NRL/MR/7441--94-7097

## Digital Mapping, Charting, and Geodesy Analysis Program Technical Review: Digital Nautical Chart Product 1

# DIGITAL MAPPING, CHARTING, AND GEODESY ANALYSIS PROGRAM TECHNICAL REVIEW: DIGITAL NAUTICAL CHART PRODUCT 1

Fig. 10 — DNC data for Ocracoke Light

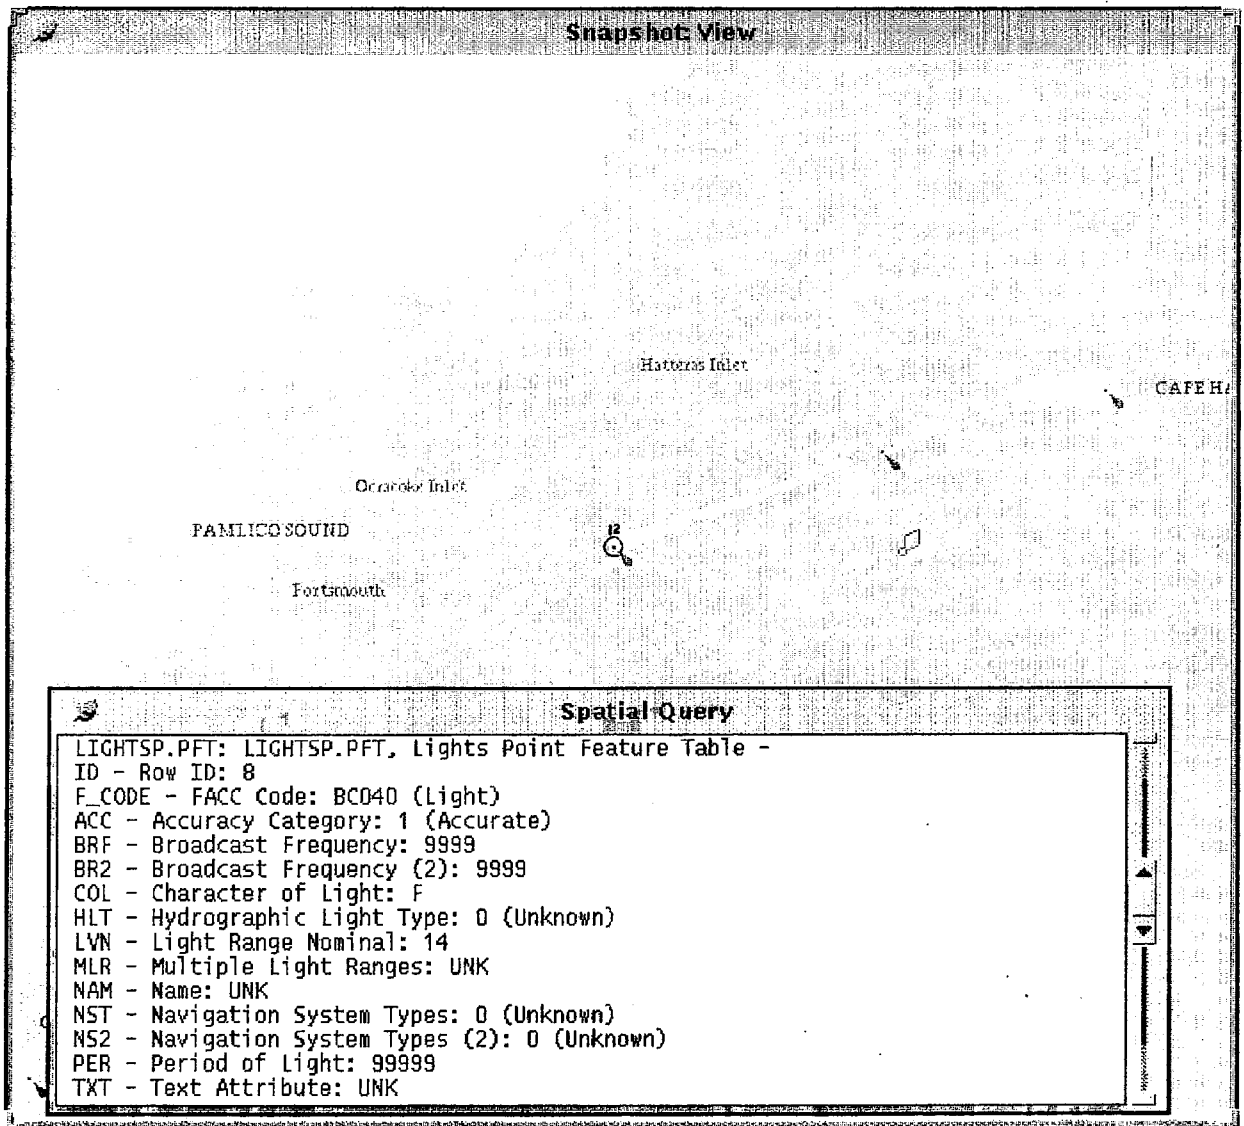
76. The attributes for Aids to Navigation should be expanded so that at a minimum they contain all of the information found in the Light List and List of Lights. This would involve adding only a few more attributes to the DNC, but the time saved for the user would be enormous (Fig. 9). Additional attributes would describe the fixed structures upon which aids are mounted, any emergency lights, any seasonal remarks (some buoys are replaced or removed during winter), any private aid identification, and the year established, moved or rebuilt. This would significantly reduce the excessive entries of "Unknown" as currently done for attribute values (Fig. 10), thus making the DNC a more complete and informative database.
